Docket Nos. 50-245

B18415

Millstone Nuclear Power Station, Unit Nos. 1, 2 and 3
Technical Specification Change Request
Administrative and Editorial Changes to the Unit Nos. 1, 2 and 3
Technical Specifications

Technical Specification Change Request
Administrative and Editorial Changes to the Unit Nos. 1, 2 and 3
Technical Specifications
Discussion of the Proposed Changes and the Safety Summary

FIGURE 5.1-1 EXCLUSION AREA

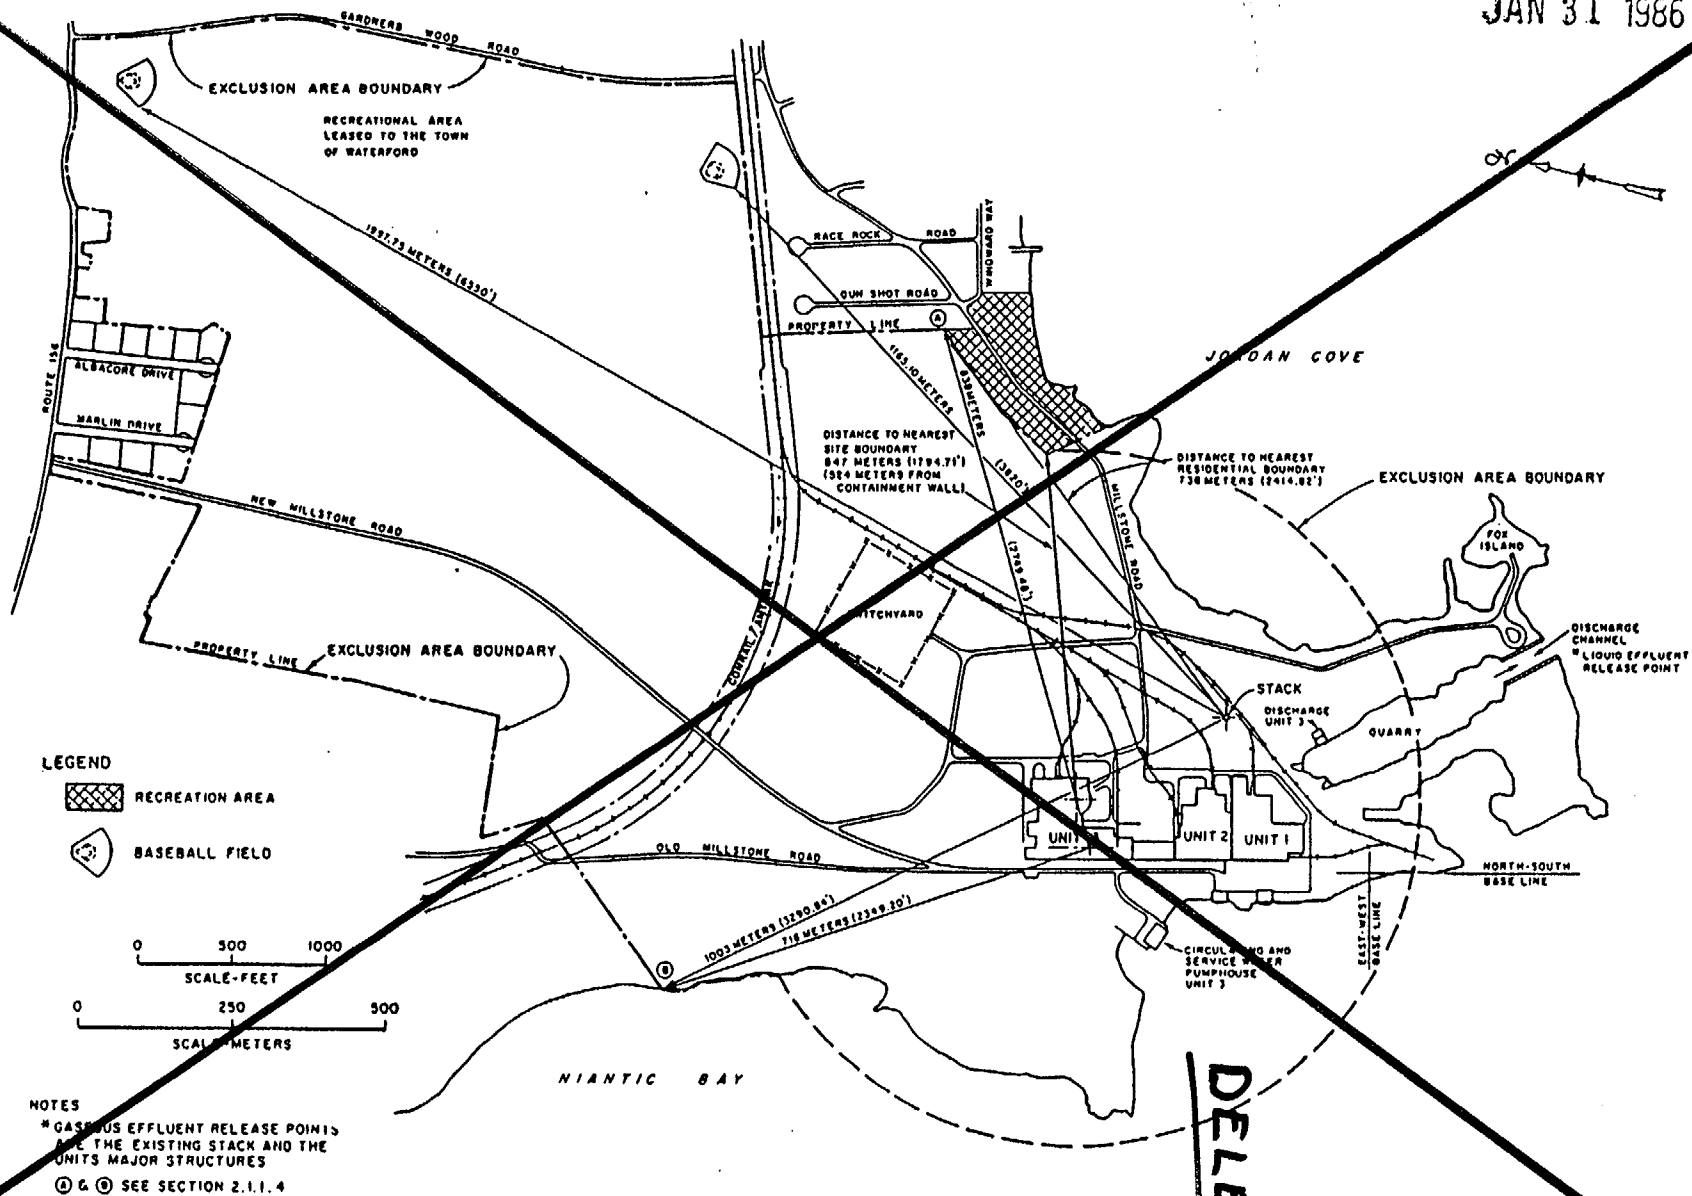
Delete Specification 5.1.1 and corresponding Figure 5.1-1, both named "Exclusion Area," and replace them with Specification 5.1, "Site Location." Unit No. 3 FSAR Section 2.1.1.3, "Boundaries for Establishing Effluent Release Limits," discusses the EAB for the site. Since each unit has several radioactive effluent release points, Unit No. 2 FSAR Table 2.3-1 provides the distances (for each sector) for Unit 2 and Unit No. 3 FSAR Table 2.3-34 provides the distances (for each sector) for Unit No. 3 for the distance from each release point to the EAB. Unit Nos. 2 and 3 FSAR Sections 2.3.4, "Short-Term (Accident) Diffusion Estimates," describes the application of the methodology. Unit No. 2 TS Figure 5.1-1 is equivalent to, and Unit No. 3 TS Figure 5.1-1 corresponds to, Unit No. 3 FSAR Figure 2.1-3. The Unit No. 2 FSAR, Section 2.1, "General Description," references the Unit No. 3 FSAR Figure 2.1-3 for the EAB over land and describes in words the EAB over water for the different release points.

The guidance of NUREG-1431 and 1432 recommends inclusion of a text-only description of the site location. The NRC Staff has previously found it acceptable⁽⁷⁾ to remove figures describing the EAB provided that the text description contains adequate information pertaining to the site boundary and location. The description of the site location provided in Specification 5.1 contains equivalent information to that provided in TS Figure 5.1-1. In accordance with 10 CFR 100, the site description includes a minimum distance to the EAB to ensure that the area, for which the licensee has the authority to determine all activities including the exclusion or removal of personnel and property from the area, is clearly associated with the "place of use" referred to in Section 182.a of the Atomic Energy Act. The inclusion of this map in the Unit No. 3 FSAR, which is referenced by the other Millstone unit's, will ensure that any change to either the boundary or the zone will have to be evaluated under the 10 CFR 50.59 process.

Delete Unit No. 2 Specification 5.8 and Unit No. 3 Specification 5.5, "Meteorological Tower Location," from the respective TS. Also, the following figures which show the meteorological tower location, i.e., Figure 5.1-1, "Exclusion Area," for Unit No. 2 and Figure 5.1-3, "Site Boundary For Liquid And Gaseous Effluents," for Unit No. 3 are proposed to be removed. These

FIGURE 5.1-2 LOW POPULATION ZONE

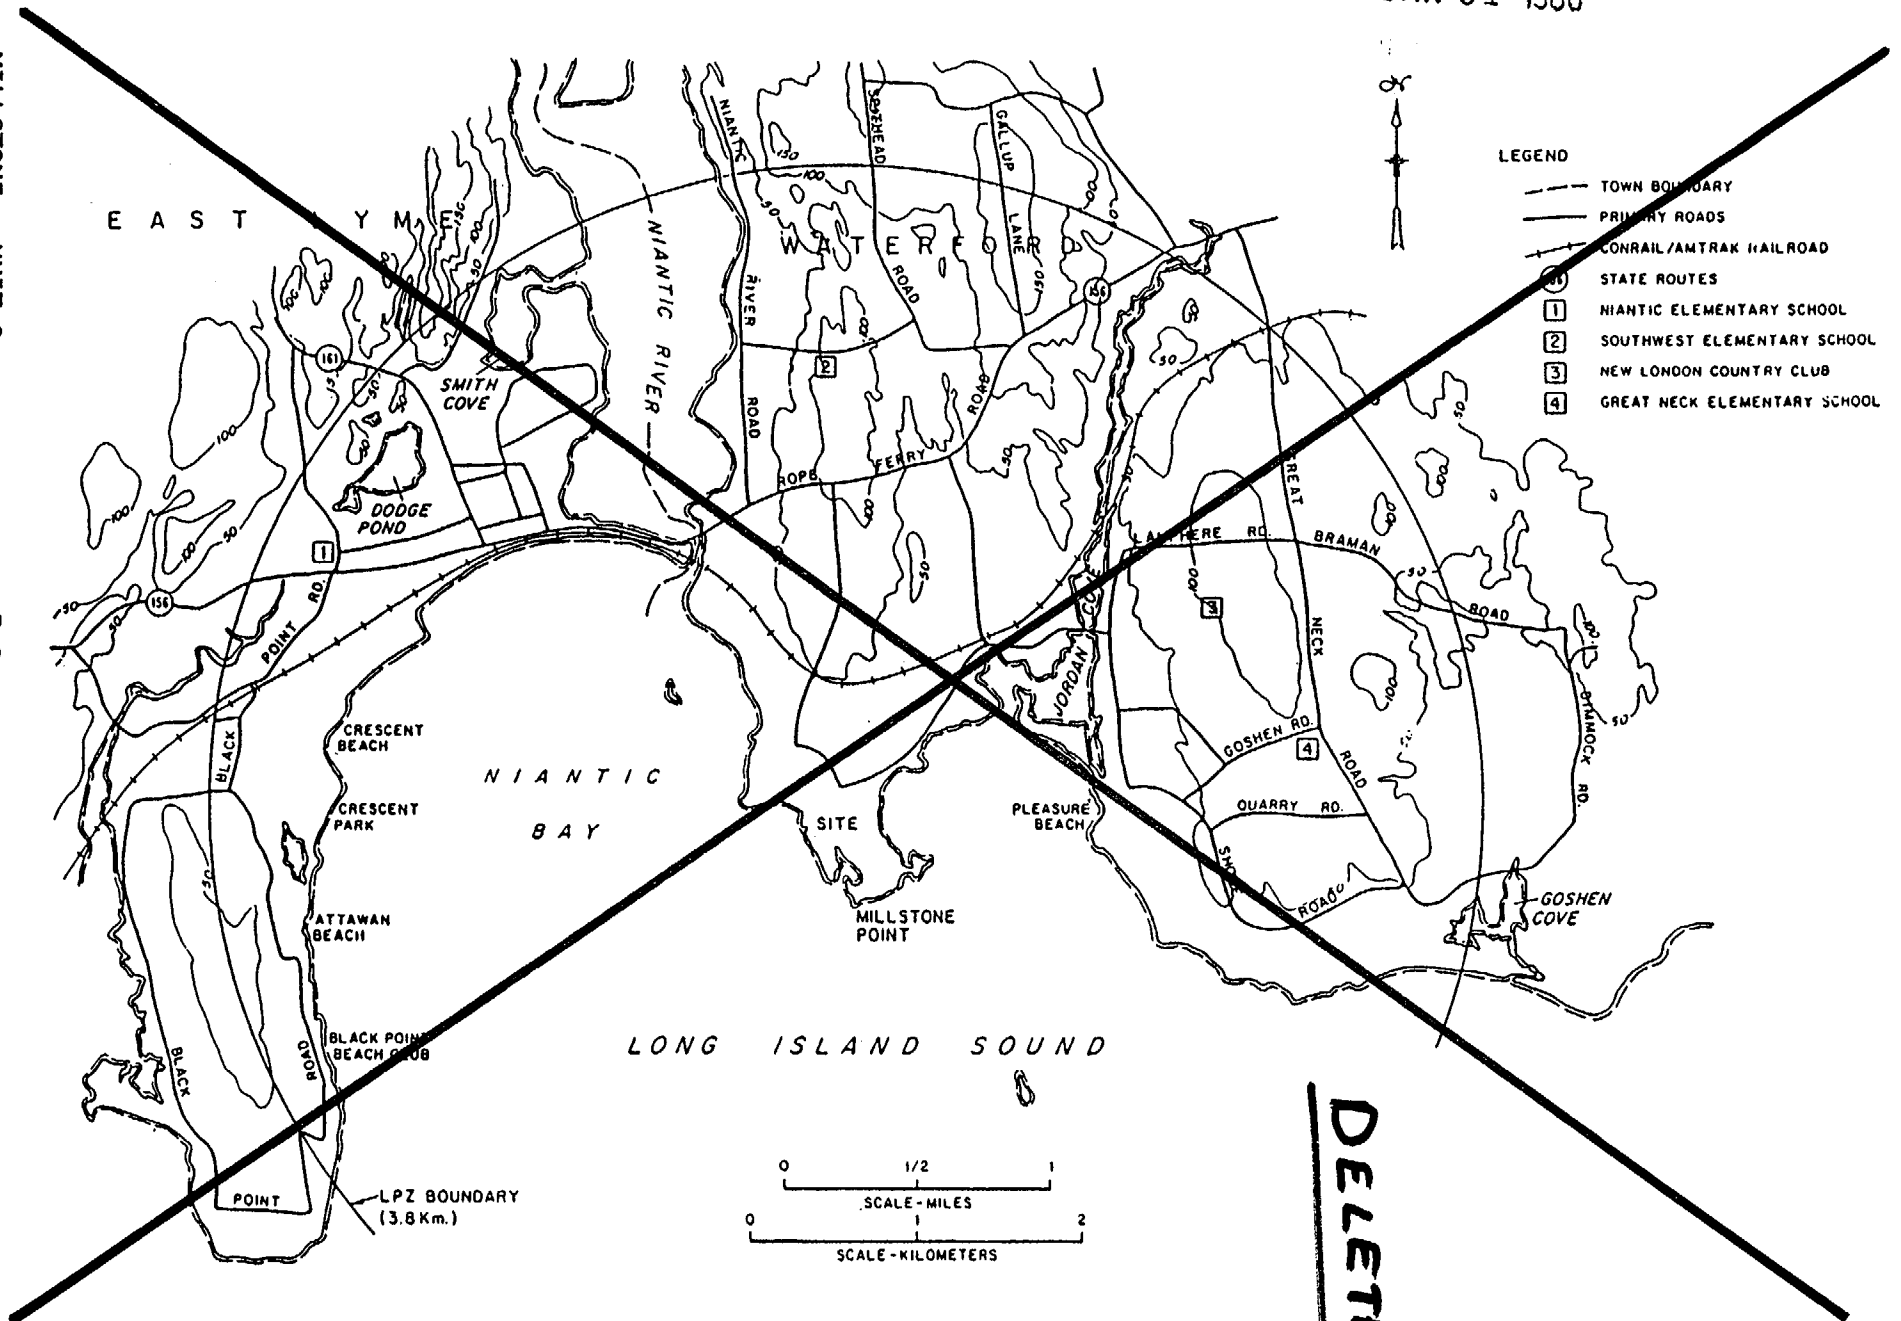
Delete Specification 5.1.2 and corresponding Figure 5.1-2, both named "Low Population Zone" (LPZ) and replace them with Specification 5.1, "Site Location." Unit Nos. 2 and 3 TS Figures 5.1-2 contain information corresponding to a textual description of the LPZ included in Section 2.1.3.4, "Low Population Zone," of the Unit No. 3 FSAR which is referenced by Section 2.1, "General Description," of the Unit No. 2 FSAR.

Figure 5.1-2 depicts the LPZ as a circle centered on the respective reactor having a 3860 meter (approximately 2.4 statute mile) radius. Removal of Specification 5.1.2 and associated Figure 5.1-2 is acceptable as this information does not meet any of the inclusion criteria for information required to be contained in the TS pursuant to 10 CFR 50.36(c)(4). The NRC has previously found it acceptable to remove figures describing the LPZ from the TS.⁽⁷⁾ This proposed change is consistent with the guidance provided in the appropriate improved STS NUREG, i.e., NUREG-1432 for Unit No. 2 and NUREG-1431 for Unit No. 3, which do not include an LPZ specification. A description of the LPZ is included in Section 2.1.3.4 of the Unit No. 3 FSAR which is referenced by Section 2.1 of the Unit No. 2 FSAR. The existence of this discussion within the Unit No. 3 FSAR (which is referenced by the Unit No. 2 FSAR) will ensure that any change to the LPZ will be evaluated under the 10 CFR 50.59 process.

FIGURE 5.1-3 SITE BOUNDARY FOR LIQUID AND GASEOUS EFFLUENTS

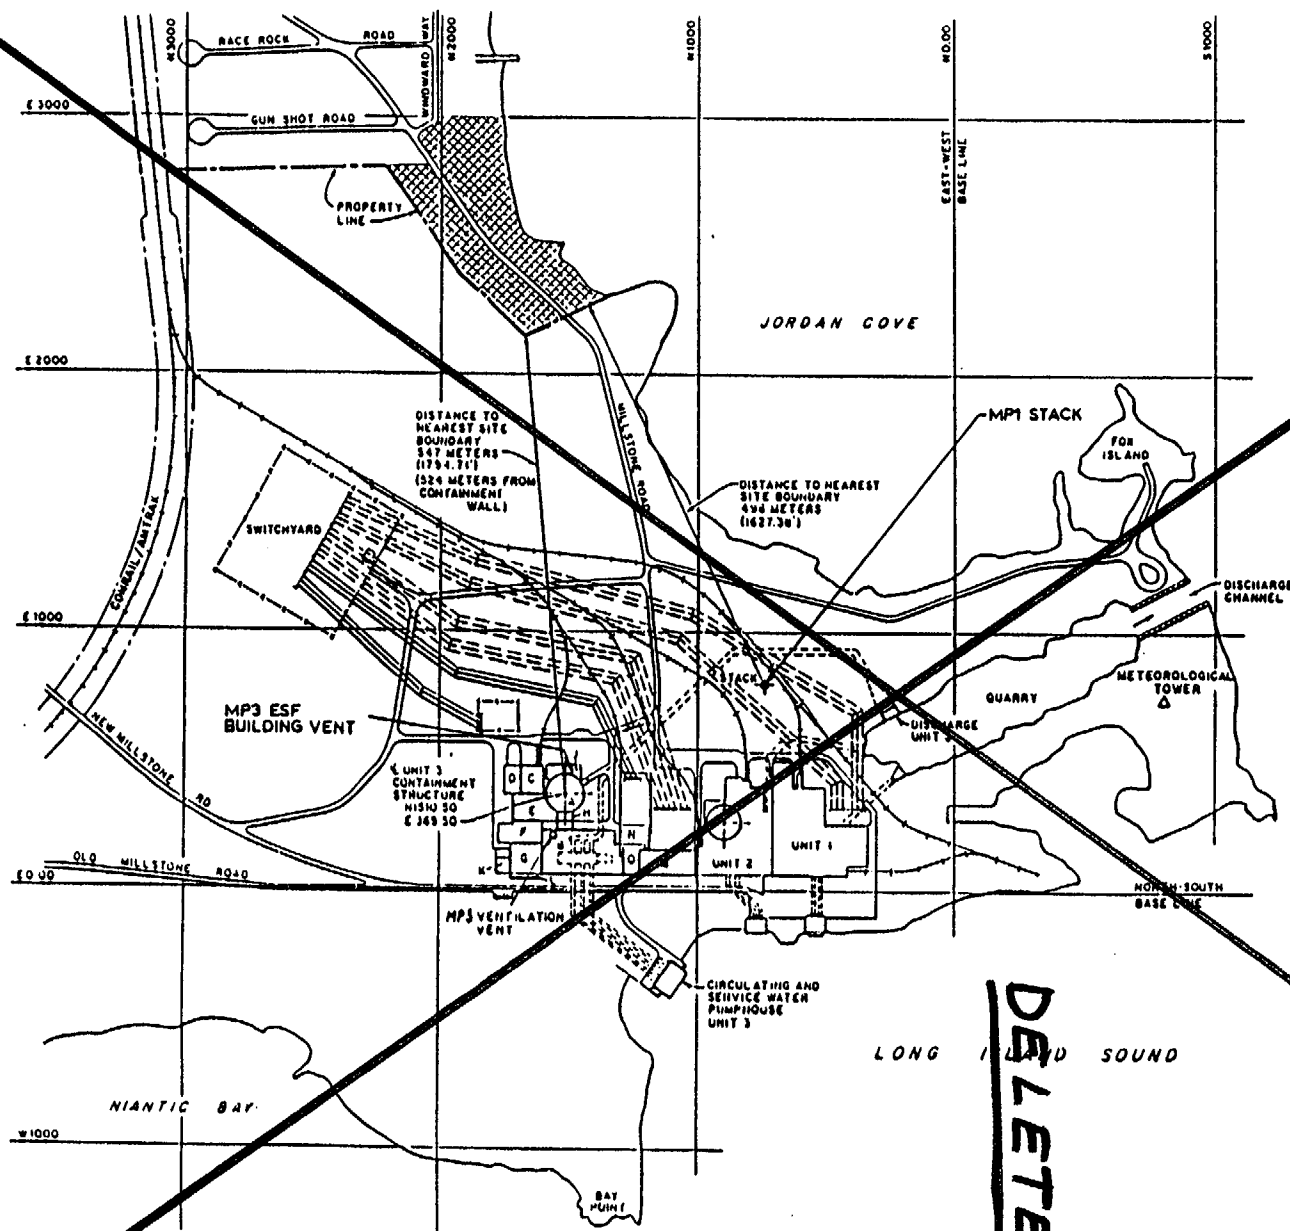
Delete Specification 5.1.3 and corresponding Figure 5.1-3, both named "Site Boundary for Liquid and Gaseous Effluents," and replace them with Specification 5.1, "Site Location." Unit No. 3 TS Figure 5.1-3 corresponds to Unit No. 3 FSAR Figure 2.1-3.

Unit No. 3 TS Figure 5.1-3 depicts the site boundary for liquid and gaseous effluents. Removal of Specification 5.1.3 and associated Figure 5.1-3 is acceptable as this information does not meet any of the inclusion criteria for information contained in TS pursuant to 10 CFR 50.36(c)(4). The NRC has previously found it acceptable to remove figures describing the EAB and LPZ from the TS and removing the figure describing the site boundary for liquid and gaseous effluents is similar in concept. This proposed change is consistent with the guidance provided in the improved STS NUREG-1431⁽²⁾ which does not include a specification for the site boundary for liquid and gaseous effluents. A description of the site boundary for liquid and gaseous effluents is included in Section 2.1.1.3, "Boundaries for Establishing Effluent Release Limits," of the Unit No. 3 FSAR. The existence of this discussion and the associated figure within the Unit No. 3 FSAR will ensure that any change to the site boundary for liquid and gaseous effluents will be evaluated under the 10 CFR 50.59 process.
